Cobb County Community Development Agency
Zoning Division

Case # Z-40

FINAL ZONING STAFF RECOMMENDATION:

SEI
 JIM CHAPMAN COMMUNITIES
 2700 CHAPMAN PARKWAY SUITE 130
 ATLANTA, GA 30328
 RSL SITE PLAN
 BELLS FERRY RD. & HOSKINS RD.
 CLAY COUNTY, GEORGIA

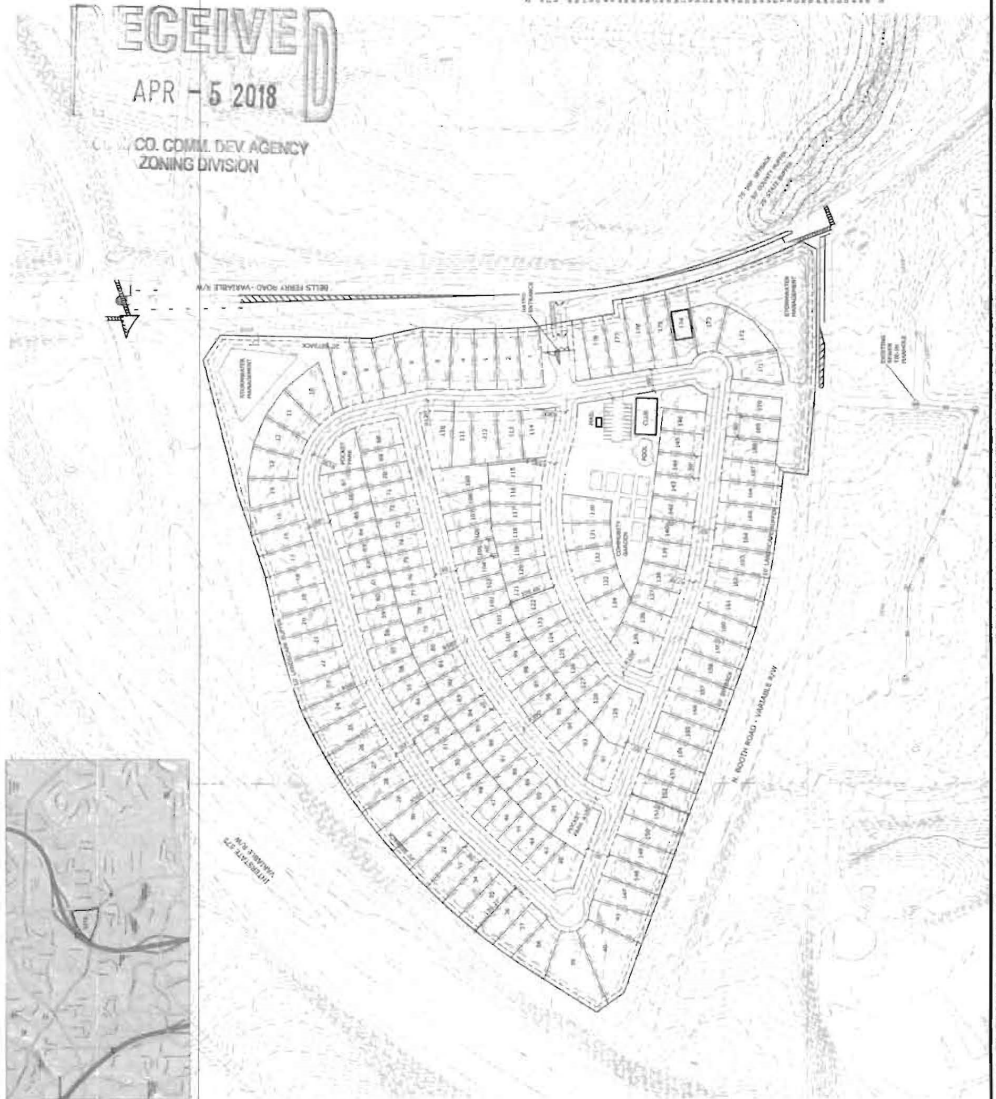
Yes, the proposal will require a contemporaneous variance to waive the minimum setback between structures from the required 15 feet to 10 feet.

Occupant parking shall be installed as required by zoning and additional guest parking shall be required as follows:

1. Where driveways to two car garages exceed 50 feet in length, no additional guest parking is required.
2. Where driveways to two car garages are at least 22 feet long and 20 feet wide, additional parking shall be required at .5 spaces per dwelling unit.
3. Where driveways to two car garages are less than 22 feet long and 20 feet wide, additional parking shall be required at 1 space per dwelling unit.
4. Where only single car garages are provided, additional parking shall be required at 2 spaces per dwelling unit.
5. Guest parking spaces must be evenly distributed throughout the project.

1. Flood hazard: No
2. Flood hazard zone: Zone X
3. Drainage Basin: Noonday Creek Tributary #1
4. Wetlands: No
5. Streambank buffer zone: No
6. Stormwater discharges must be controlled not to exceed the existing capacity of the downstream storm drainage systems.

7. Stormwater discharges through an established residential neighborhood downstream.
8. Project engineer must evaluate the impact of increased volume of runoff generated by the proposed project on existing downstream drainage system(s).

9. Special site conditions and/or additional comments:
 - The extensive existing tree stand and undergrowth provide significant air/water quality, soil stabilization and storm flow mitigation benefits for this watershed. Construction of this project will eliminate the vast majority of this vegetation and increase pavement, storm runoff and non-point source pollution. To compensate, the First Flush Water Quality Best Management Practice Requirements must be elevated to the 1.5-inch rainfall event and each larger storm discharge controlled not to exceed the allowable discharge of the next lower, more frequent storm event (ie. 5-year storm event released at 2-year rate; 10-year event at 5-year rate; etc. to 100-year event at 50-year rate).

Additional water comments: Development Standards call for a secondary water feed for a subdivision of this size. Also 12" water main in North Booth Rd

Additional sewer comments: Sewer flow study is required of applicant to confirm downstream sewer line capacity if connection is proposed to sewer on west side of Bells Ferry Rd. **Line

4. Recommend curb and gutter along both sides and sidewalk along one side of proposed development roadway.
5. Recommend private streets be constructed to the Cobb County Standard Specifications.

9. Recommend the call box for the proposed gate be set back a minimum of 50' from the right-of-way and meet Cobb County Development Standards.
10. Recommend a no access easement for the lots that border Bells Ferry Road and North Booth Road.

1. Site plan received by the Zoning Division on April 5, 2018, with the District Commissioner approving minor modifications;
2. Variance listed in the Zoning comments;
3. District Commissioner to approve final site plan;
4. Fire Department comments and recommendations;
5. Water and Sewer Division comments and recommendations;
6. Stormwater Management Division comments and recommendations; and
7. Department of Transportation comments and recommendations.
